INTRODUCTION

This chapter provides responses to the substantive comments on the Draft EIS (DEIS) made either verbally at the Public Hearings on the DEIS held on March 9, 2022 and April 13, 2022, or provided to the City of Yonkers Planning Board (the “Planning Board”), as Lead Agency, from February 2, 2022 through April 27, 2022. A list of commenters is provided below. The full transcripts of the Public Hearings and the correspondence from which the comments are drawn are included in **Appendix A**. Comments having a similar subject or raising similar technical points are grouped together. In some cases, for ease of reading, an introduction to a group of similar comments is provided (see e.g., Comment Gen-5).

AMS Yonkers Downtown Development

Chicken Island Stage 1 Site Plan
Figure 3-5

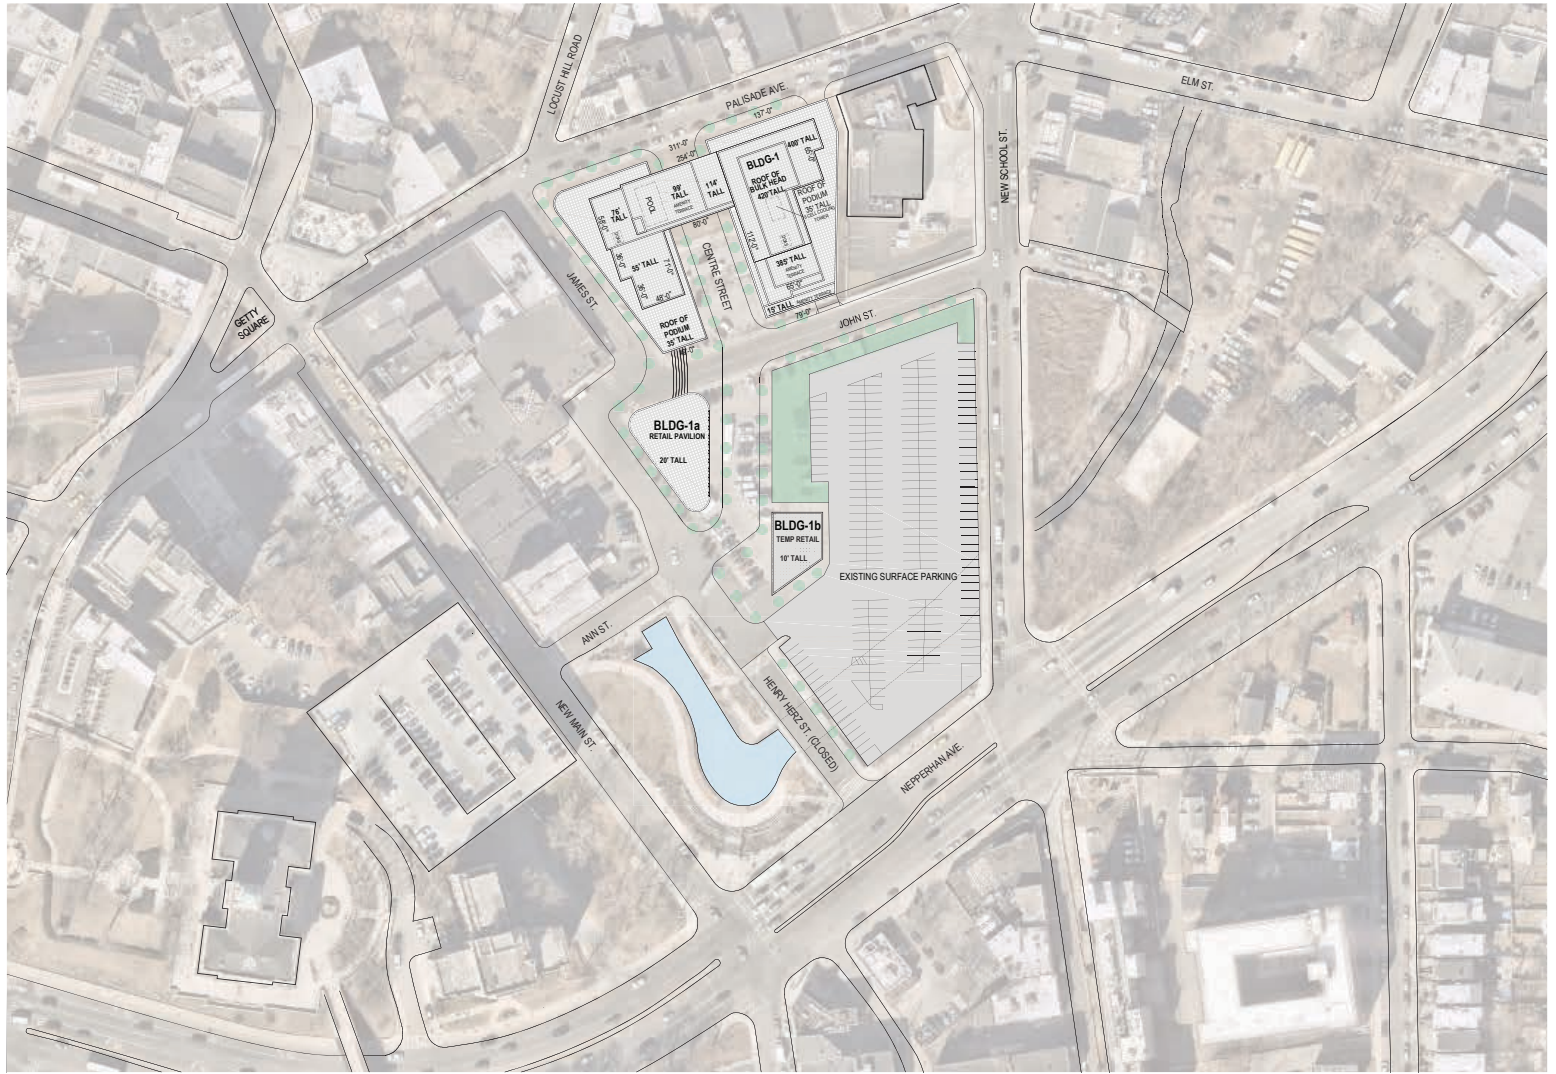
Comment Gen-14: Figure 1-17 – Update aerial base map to more current imagery. (Nersinger_031)

Response Gen-14: DEIS Figure 1-17 has been updated and reprinted as FEIS **Figure 3-5**.

Chicken Island Proposed Attended Garages - Phase 2
Figure 3-7

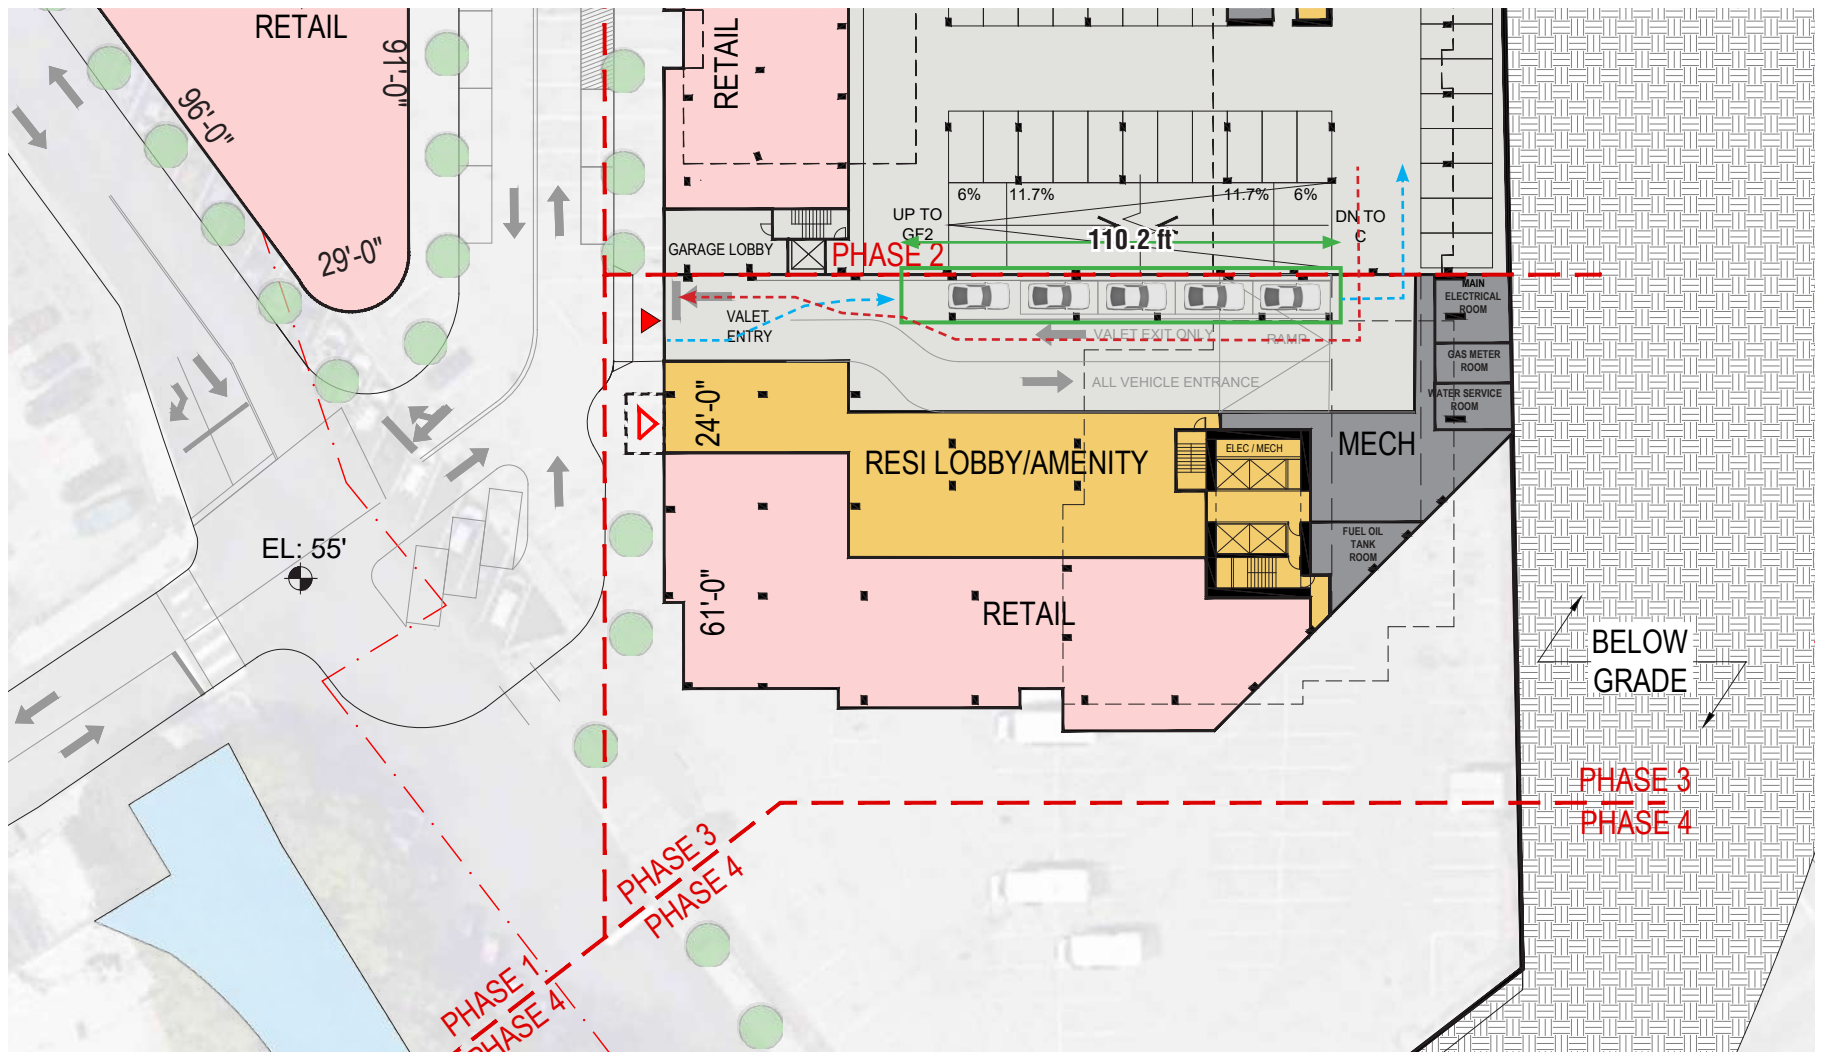
- Comment 1-22:** Proposed valet parking should not use parking lanes and streets to accommodate the queueing that should be available inside the garage. The proposal to queue and then drive to an entrance fully around the block needs to be rethought. (Nersinger_031)

- Comment 1-23:** Fig. 1-30 Attended parking proposal. This layout seems impossible even under best possible machine learning scenario where cars are placed based upon learned need of owners. There needs to be space to maneuver cars and they cannot be stacked like Lego blocks. A more realistic arrangement, or a clearer explanation of how the robo-parking system will work, must be produced with sufficient staging area for waiting cars. (Nersinger_031)

- Response 1-22:** Queuing for the proposed attended and automated garages would not occur on the streets or in parking lanes. **Figures 3-7 and 3-8** illustrate the location of the proposed attended and automated garages, as well as indicate the areas proposed to be used for queuing, including the queue length in feet and approximate number of cars. Chicken Island Phase 2 will have an internal queuing length of approximately 124 feet, or six to seven vehicles. Chicken Island Phase 3 will have an internal queuing length of approximately 110 feet, or five to six vehicles. Additional queuing capacity could be utilized on the levels above/below the vehicular entrances.

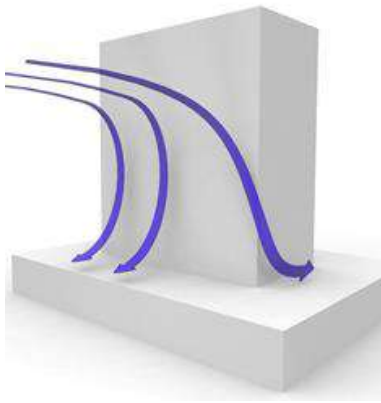
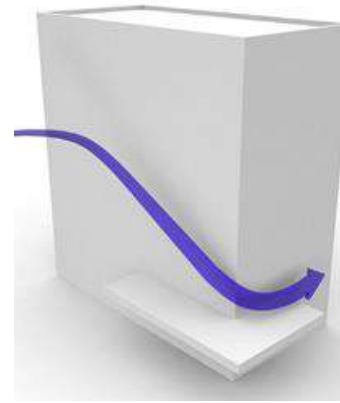
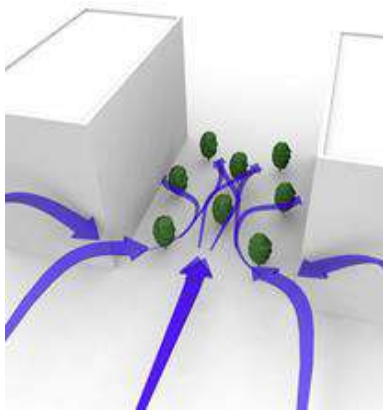
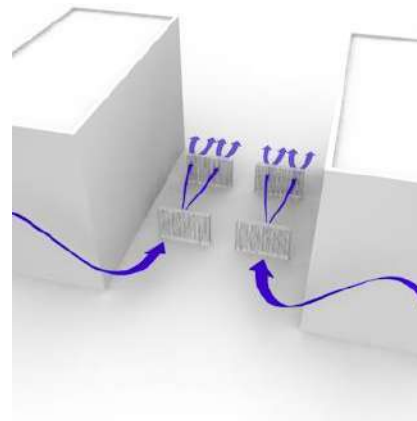
Comment 3-20: In the Chicken Island Site, the commercial plaza is noted as an area where wind will be an issue. How will this affect the use of this double-sided retail corridor? What design changes can be made to reduce the impact? (Nersinger_031)

Response 3-19: Examples of features/design details that are effective year-around include: deep canopies close to ground level, wind screens, and tall coniferous trees that retain their foliage throughout the year (see **Figure 3-11**). The choice and effectiveness of these measures would depend on the exposure and orientation of the site with respect to the prevailing wind directions and the size and massing of the proposed buildings. Recommendations specific to each Project Site were summarized in DEIS Chapter 3 and described in Appendices E-2 and E-3 of the DEIS and will be further evaluated during site plan review.
